**From:** WELLS Russell (AREVA) [Russell.Wells@areva.com]  
**Sent:** Monday, February 28, 2011 2:22 PM  
**To:** Tesfaye, Getachew  
**Cc:** BENNETT Kathy (AREVA); DELANO Karen (AREVA); ROMINE Judy (AREVA); KOWALSKI David (AREVA)  
**Subject:** Response to U.S. EPR Design Certification Application RAI No. 277, FSAR Ch. 9, Supplement 14  
**Attachments:** RAI 277 Supplement 14 Response US EPR DC.pdf

**Request for Additional Information No. 277, Supplement 14**

**U.S. EPR Standard Design Certification**

**Docket No. 52-020**

Figure 2.6.7-4—Electrical Division of Safeguard Building Ventilation System Division 2 and Division 3 Air Supply and Exhaust Functional Arrangement

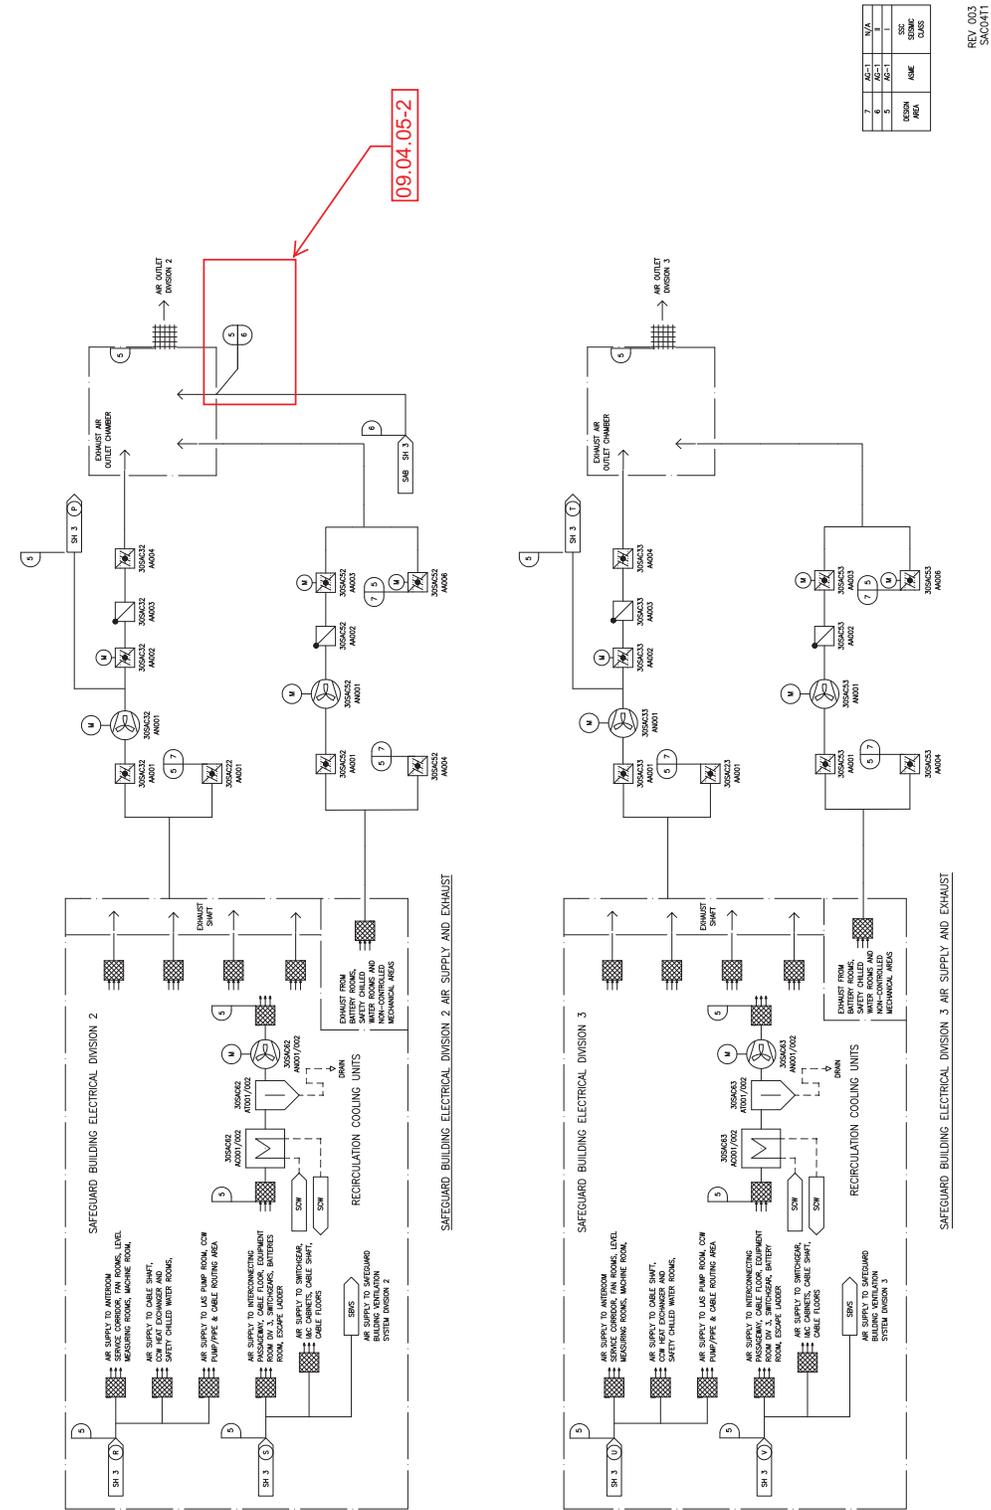
Since the SBVS fire dampers are classified as Seismic Category II (FSAR Tier 2 Table 3.2.2-1), they are not expected to function after an SSE (RG 1.29 Position C.2). The fire dampers after an SSE can be assumed to fail closed, thereby isolating the SB rooms from the normal and accident exhaust trains in each of the four SBVS divisions. Additionally, Seismic Category II ductwork can be assumed to deform (restricting airflow) but not impact or cause harm to a Seismic Category I SSC. Finally any nonsafety-related active component can be assumed to fail when challenged during any accident.

The applicant is requested to either show that potential failure of these components will not reduce the safety function of the SBVS or classify the components as Seismic Category I.

U.S. EPR FSAR Tier 1, Figure 2.6.7-4—Electrical Division of Safeguard Building Ventilation System Division 2 and Division 3 Air Supply and Exhaust Functional Arrangement and U.S. EPR FSAR Tier 2, Figure 9.4.6-4—Safeguard Building Electrical Divisions 2 and 3 Air Supply and Exhaust, will be revised to eliminate inconsistencies and provide additional description of non-safety-related heaters.

U.S. EPR FSAR Tier 1, Figure 2.6.7-4 and U.S. EPR FSAR Tier 2, Figure 9.4.6-4 will be revised as described in the response and indicated on the enclosed markup.
